October 12, 2007
LIC-07-0054

SUBJECT: Fort Calhoun Station Unit No. 1, License Amendment Request (LAR), "Uprate of Shutdown Cooling (SDC) System Entry Conditions"

Omaha Public Power District's Evaluation of the Proposed Change

RCS PRESSURE AND TEMPERATURE LIMITS

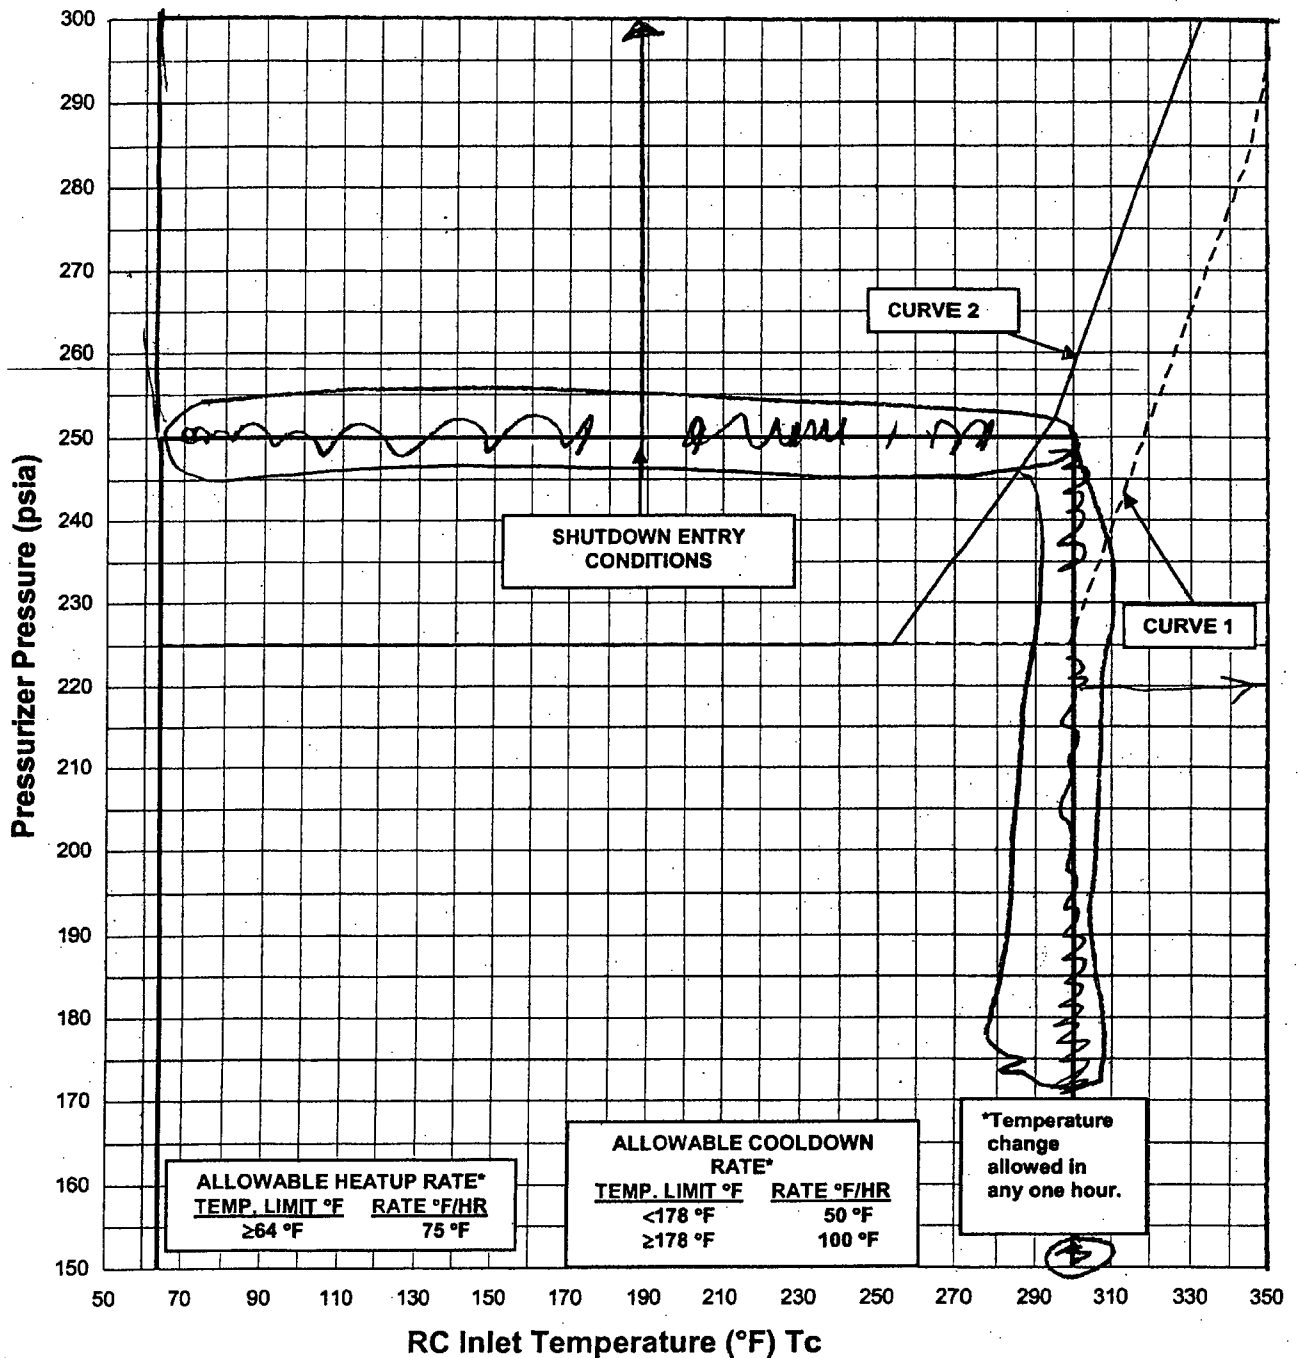
Change No.	EC-30302 35639
Reason for Change	Changes made to the pressure and temperature (P-T) limit curve, Reactor Coolant Pump (RCP) net positive suction head (NPSH) curve, and the PORV trip and pretrip curves. Also, the EFPY for the applicability of this figure is being adjusted to 40 EFPY since the measurement uncertainty recapture power uprate has not occurred.
Requestor	L. Hautzinger
Preparer	D. Bonsall
Issue Date	11-10-06 3:00pm

Reason for change:

Update information associated with
uprate of SDC initiation conditions
